Access Compliance Report Public Rights-of-Way (Curb Ramps)

Intersection ID: 10027410 Main Street: GOLF_ACRES_DR Cross Street: N/A Location: N

ADA ID: 57ABB24D5043 Ramp Type: Perp Initial Pass/Fail: Fail Overall Compliance: No Severity Score: 33.75

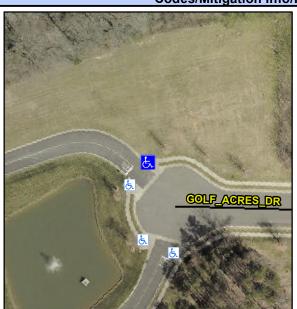
R304.5.1, R304.5.3

Comp	liance Description	Data	Comp	liance Descript	ion	Data
N/A	Ramp Length (in)	46.5	Yes	Ramp Slope (%	o)	5.2
No	Ramp Width (in)	40.0	No	Ramp XSlope (%)	7.0
N/A	Flare Type LT	N/A	N/A	Flare Type RT		N/A
N/A	Flare Slope LT (%)	N/A	N/A	Flare Slope RT	(%)	N/A
N/A	Flare Traversable LT?	N/A	N/A	Flare Traversal	ole RT?	N/A
N/A	Landing Length (in)	N/A	N/A	DWS Provided	?	N/A
N/A	Landing Width (in)	N/A	N/A	DWS Contrast?	•	N/A
N/A	Landing Slope (%)	N/A	N/A	DWS Length (in	٦)	N/A
N/A	Landing X Slope (%)	N/A	N/A	DWS Full Width	1?	N/A
N/A	Landing Curb? (Y/N)	N/A	N/A	DWS Offset (in)	N/A
N/A	Shared Landing?	N/A				
N/A	Gutter Ponding?	N/A	N/A	Gutter Slope (%	6)	N/A
N/A	Gutter Lip Ht (in)	N/A	N/A	Gutter X Slope	(%)	N/A
N/A	Painted X Walk1?	No	N/A	Painted X Walk	2?	N/A
	X Walk 1 Direction	To SW		X Walk 2 Direct	tion	N/A
N/A	X Walk 1 Width (in)	N/A	N/A	X Walk 2 Width	(in)	N/A
	X Walk 1 Slope (%)	0.5		X Walk 2 Slope	(%)	N/A
	X Walk 1 X Slope (%)	2.6		X Walk 2 X Slo	pe (%)	N/A

Remove & Replace Entire Ramp.
